UNITED STATES PATENT AND TRADEMARK OFFICE

APPLICATION NO.	FILING DATE	FIRST NAMED INVENTOR	ATTORNEY DOCKET NO.	CONFIRMATION NO.
10/798,779	03/12/2004	David G. Filippi	COLME-0004	5631
<div>7590 JOHN H THOMAS 536 GRANITE AVENUE RICHMOND, VA 23226</div>			<div>EXAMINER CAJILIG, CHRISTINE T</div>	
			<div>ART UNIT 3637</div>	<div>PAPER NUMBER</div>
SHORTENED STATUTORY PERIOD OF RESPONSE		MAIL DATE	DELIVERY MODE	
3 MONTHS		02/20/2007	PAPER

Office Action Summary

DETAILED ACTION

FIG. 3

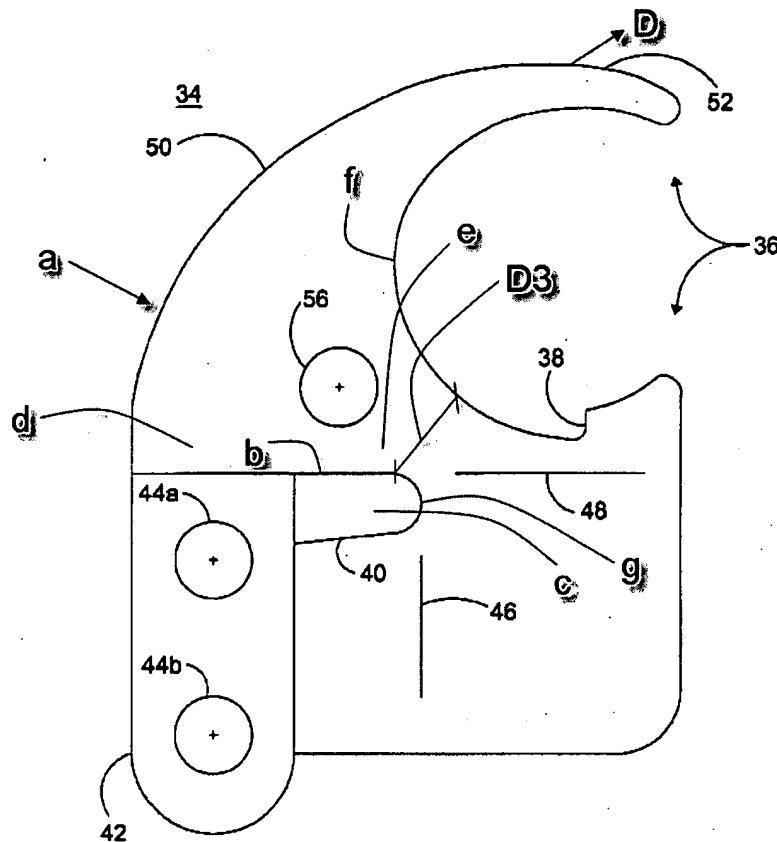
Regarding claims 42 and 65, Stevens in Figures 2 and 3 discloses a gutter-cover system for spacing a wall (20, 22, 24) of a gutter (4) from a gutter cover (2) comprising a cover (2), said cover comprising a solid sheet (2) having one longitudinal edge thereof formed into a curl (12) and wherein the cover (2) extends downwardly and outwardly from the lowermost edge of a roof (8) so that said curl (12) extends downwardly toward said gutter (4); a gutter-cover clip (34) having a substantially flat body portion (a) inherently having a thickness; said body portion (a) comprising a first throat portion (36) having first (52) and second (38) jaws thereof and shaped so that said first throat (36) portion is adapted to engage said curl (12) of said cover (2); third (b) and fourth (40) jaws and a second throat (c) located therebetween, said second throat (c) being adapted to engage said wall (22, 24) of said gutter (4) between said third (b) and fourth (40) jaws; and, at least a first locking lever (d) adjacent said third jaw (b) and joined to

said body (a) portion by a hinge (e), said first locking lever (d) being adapted to be bent at said hinge (e) to bring said third jaw (b) into a locking position against said gutter (4) as seen in Figure 2.

Regarding claim 55, Stevens in Figure 2 discloses a gutter-cover system wherein said clip (34) is adapted to lock onto a vertical gutter wall portion (throat 40 in Figure 5a is capable of locking onto a vertical gutter wall) and wherein said third (b) and fourth (40) jaws are essentially parallel to said vertical gutter wall (24). No patentable weight is given to the structure of a gutter since the gutter is claimed as an intended use.

Regarding claim 62, Stevens in Figures 2 and 3 discloses a gutter-cover system wherein the deepest part (f) of said first throat (36) and the deepest part (g) of said second throat (c) lie essentially in a common plane.

Doussot et al. (U.S. Patent No. 5,426,832)

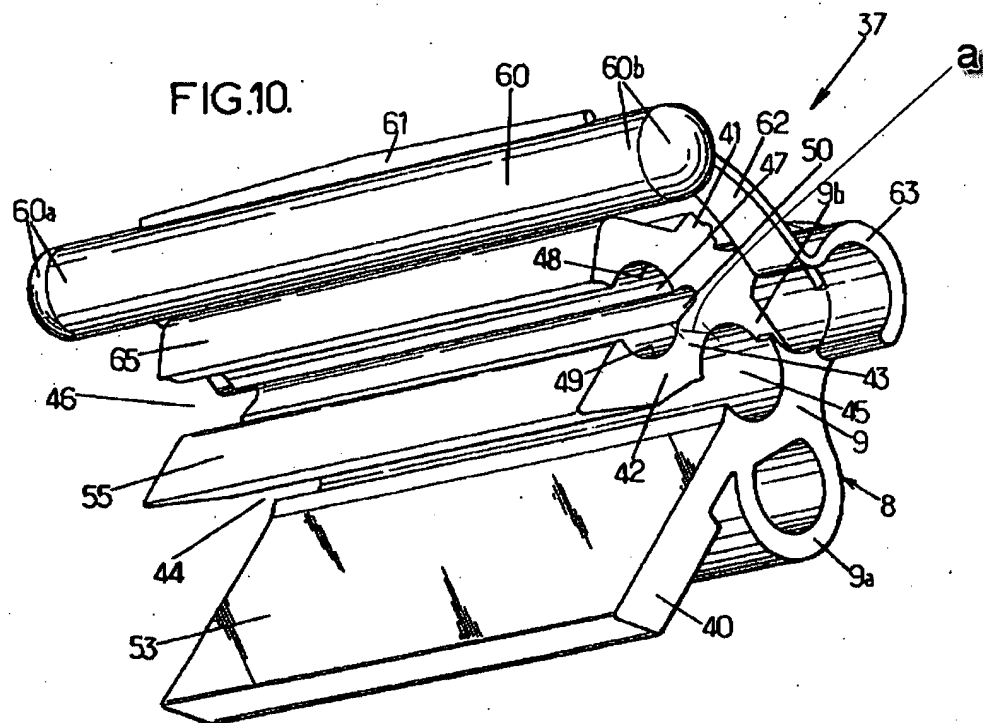
Regarding claim 43, Stevens discloses a gutter-cover system as discussed above but does not disclose a gutter-cover system further including a bending slot in said body portion, said bending slot being located above said second throat so that said hinge is between said second throat and said bending slot, said hinge having a width (D3) whereby a force applied to said bending slot moves said locking lever about said hinge so that said third jaw is brought into locking engagement with said wall of said gutter. However, Doussot et al. in Figures 10 and 13 discloses a fixing clip including a bending slot (46) in a body portion (37), said bending slot (46) being located above a second throat (45) so that a hinge (43) is between said second throat (45) and said bending slot (46) and having a width (a) whereby a force applied to said bending slot (46) moves a locking lever (55) about said hinge (43) so that a third jaw (57) is brought into locking engagement with a rod (4). Stevens and Doussot et al. are analogous art because they are pertinent in the problem of securing a member via a clip. Therefore, it would have been obvious to a person having ordinary skill in the arts at the time of the applicant's invention to modify the clip of Stevens to include a bending slot in said body portion, said bending slot being located above said second throat so that said hinge is between said second throat and said bending slot and having a width (D3) whereby a force applied to said bending slot moves said locking lever about said hinge so that said third jaw is brought into locking engagement with said wall of said gutter as taught by Doussot et al. to further clamp down on an object that needs to be secured, in this case, the gutter wall (Col 10, Ln 3-17).

locking lever about said hinge so that said third jaw is brought into locking engagement with said wall of said gutter. However, Doussot et al. in Figures 10 and 13 discloses a fixing clip including a bending slot (46) in a body portion (37) located adjacent said third jaw (57) so that a hinge (43) is between said third jaw (57) and said bending slot (46) and having a width (a) whereby a force applied to said bending slot (46) moves a locking lever (55) about said hinge (43) so that a third jaw (57) is brought into locking engagement with a rod (4). Stevens and Doussot et al. are analogous art because they are pertinent in the problem of securing a member via a clip. Therefore, it would have been obvious to a person having ordinary skill in the arts at the time of the applicant's invention to modify the clip of Stevens to include a bending slot in said body portion located adjacent said third jaw so that said hinge is between said third wall and said bending slot whereby a force applied to said bending slot moves said locking lever about said hinge so that said third jaw is brought into locking engagement with said wall of said gutter as taught by Doussot et al. to further clamp down on an object that needs to be secured, in this case, the gutter wall (Col 10, Ln 3-17).

Regarding claims 63 and 66, Stevens discloses a gutter-cover system as discussed above but does not disclose a gutter-cover system further including a bending slot in said body portion located above said second throat and wherein the ratio of the distance between said first throat and said bending slot to the thickness of said hinge is between about 1.1 and 2.0. However, Doussot et al. in Figures 10 and 13 discloses a fixing clip including a bending slot (46) in a body portion (37), and said bending slot (46) being located above a second throat (45). Stevens and Doussot et al.
